SPECIAL CAP MEETING – 6 MARCH 2024

ITEM 8.1

DEVELOPMENT NO.:	23020199
APPLICANT:	Development Holdings Pty Ltd
ADDRESS:	52 POMONA RD STIRLING SA 5152
NATURE OF DEVELOPMENT:	Change of use to childcare centre including alterations and additions to a Local Heritage Place, deck, retaining walls and fencing with associated car parking and landscaping
ZONING INFORMATION:	<p>Zones:</p> <ul style="list-style-type: none"> • Rural Neighbourhood <p>Subzones:</p> <ul style="list-style-type: none"> • Adelaide Hills <p>Overlays:</p> <ul style="list-style-type: none"> • Hazards (Bushfire - Medium Risk) • Local Heritage Place • Mount Lofty Ranges Water Supply Catchment (Area 2) • Native Vegetation • Prescribed Water Resources Area • Regulated and Significant Tree • Traffic Generating Development <p>Technical Numeric Variations (TNVs):</p> <ul style="list-style-type: none"> • Minimum Site Area (Minimum site area is 2,000 sqm)
LODGEMENT DATE:	18 July 2023

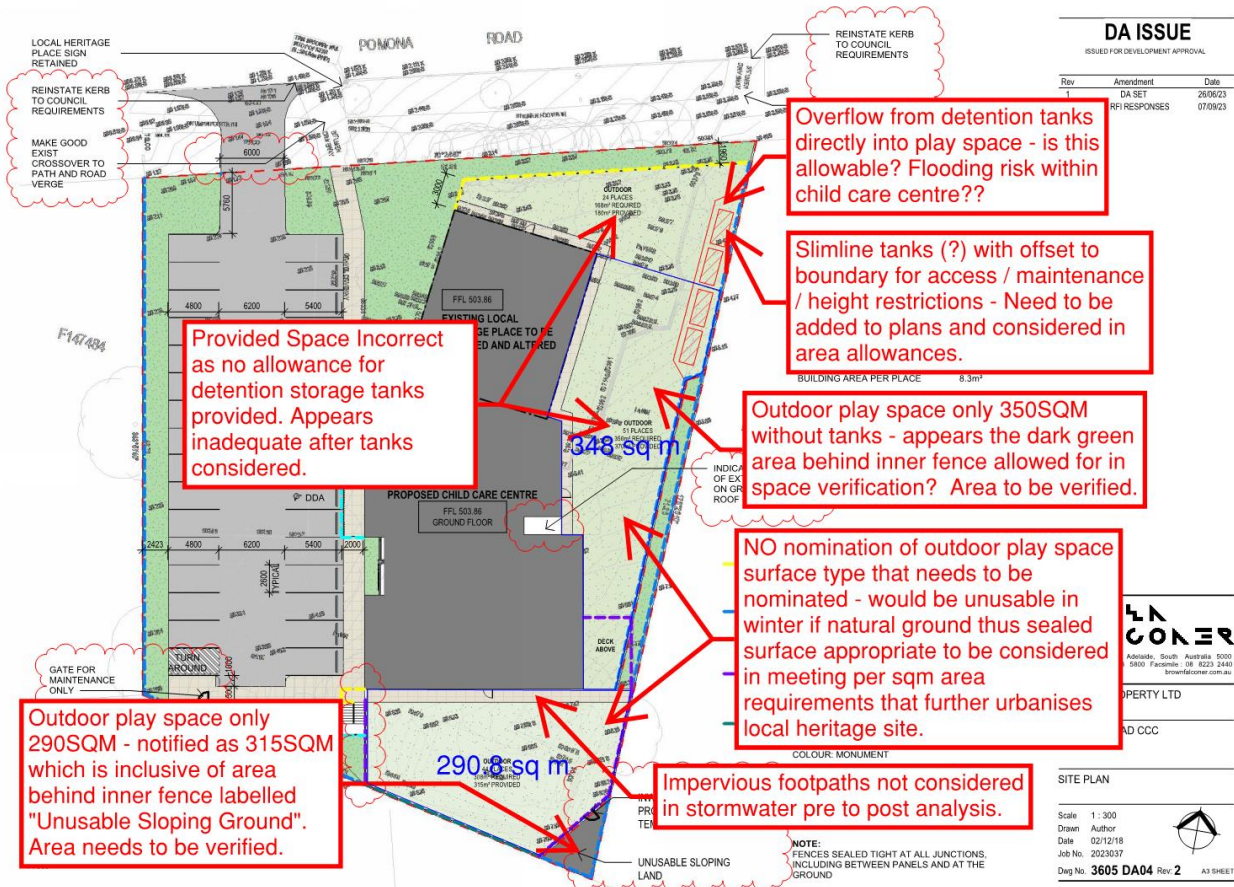
- Drawing No 3605 DA02 details approximate distances from a tree within the SW corner to adjacent properties. This advice is then used in Ekistics Planning Statement Section 2 where *a second tree, Acer pseudoplatanus has a trunk circumference of 3.4m (measured from 1m above natural ground level) but is located within 20m of a dwelling on adjoining land*. The approximate distances to adjacent properties detailed on the DA Plans should not be used as

- Drawing No 3605 DA04 Does not allow for the 20kL of stormwater tanks required as detailed in the Stormwater Management Plan. This will reduce the available outdoor space as detailed in the image below.
- The Outdoor Space areas notified on Drawing No 3605 DA04 in Area #2 (East) and Area #3 (South) appear to be incorrect as they include the area of unusable land behind the inner fences. Once excluded the area does not meet space provisions. The below image illustrates the available outdoor area using a scaled PDF.

Figure 3 – Locality Plan showing heritage places [Source: SA Property & Planning Atlas 2023]

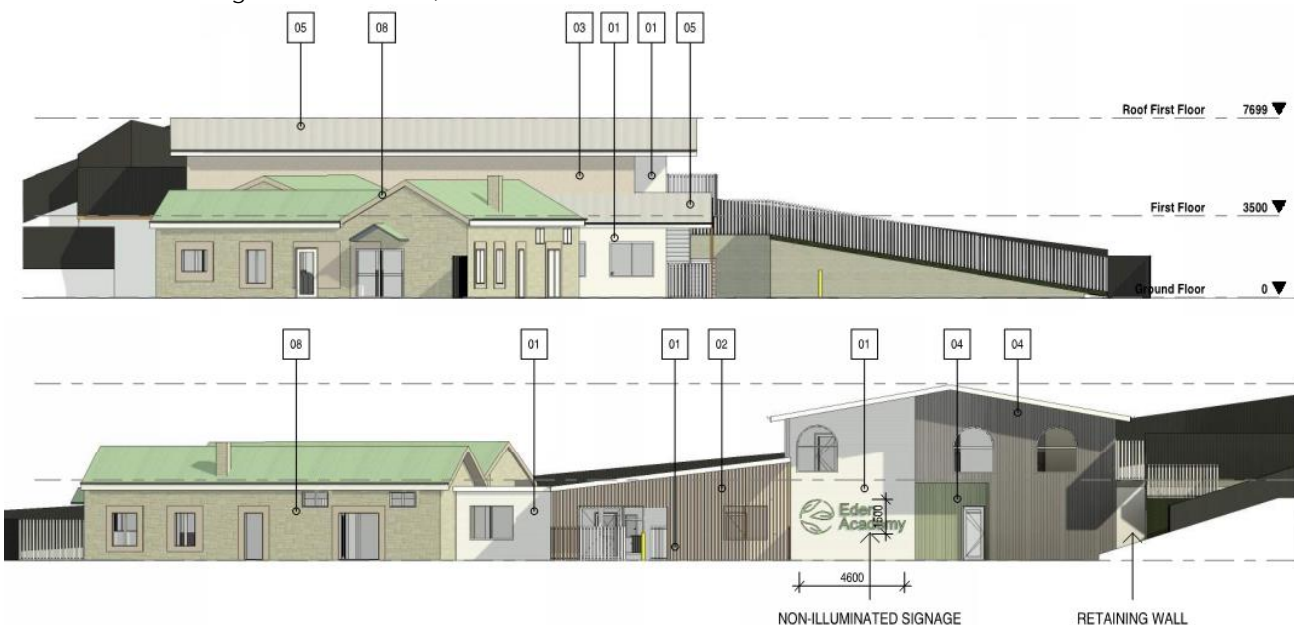
- Section 5.2 Adaptive Reuse refers to provisions of the Local Heritage Place Overlay (LHPO) that are relevant to the application including *PO2.2 Adaptive reuse and revitalisation of Local Heritage Places to support their retention in a manner that respects and references the original use of the Local Heritage Place*. The heritage consultant concludes that ‘None are applicable’ yet in in Section 3.2 Figure 3.1 as copied below the heritage listed Local Heritage

- Section 5.2 continues to compromise the heritage assessment by making unfounded statements including: *In the absence of an internal inspection and based on a review of recent real estate photos, internal spaces appear to have generally been altered widely*. This is surprising after previously concluding in Section 3.5 that the extent and timing of the building alterations are unknown.

Figure 2-3 Before and After Comparison of Updated Retaining Wall Location

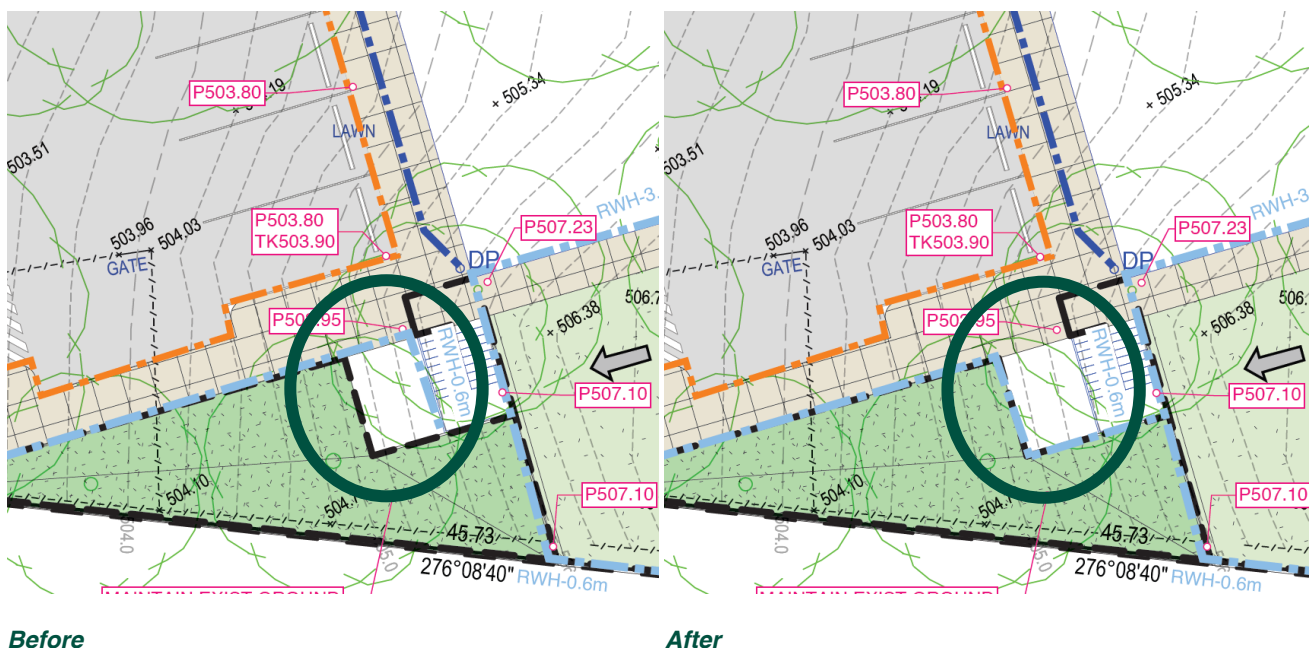
In relation to bin collection, the bins will be located on the same level as the car park. The stormwater management plan has been updated to reflect the correct retaining wall location, as depicted below in **Figure 2-4**. In addition, the site plan has been updated to correctly depict a 1.8m tall fence forward of the waste area. Accordingly, waste collection staff will park the truck, wheel bins from the dedicated waste storage area to the back of the truck, empty the bins, and wheel the bins back to the waste storage area, and leave the site.

Figure 1 – minimum sight lines for pedestrian safety as identified in the Australian Standards (AS2890.1:2004)

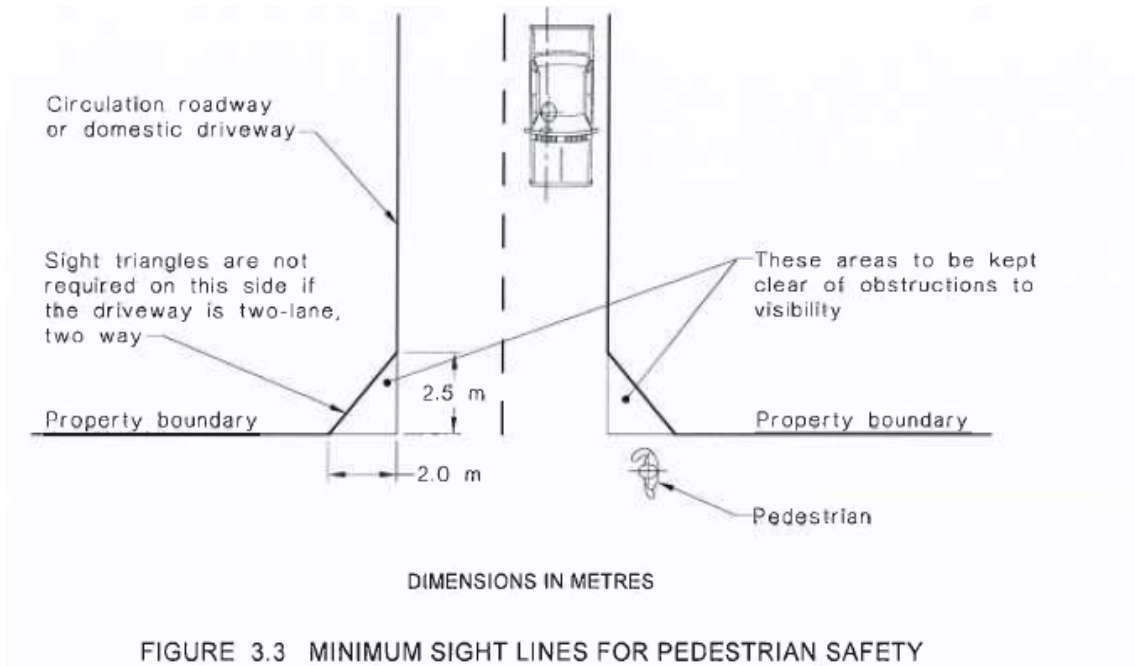
Representors have raised concerns about sight lines at the proposed access point and the potential conflict between vehicles and pedestrians. The Australian Standards (AS/NZS 2890.1:2004) identify a pedestrian sight line provision of 2.0 m by 2.5 m (measured from the property boundary) to accommodate sight lines between pedestrians and a vehicle exiting the site (refer Figure 1 below).
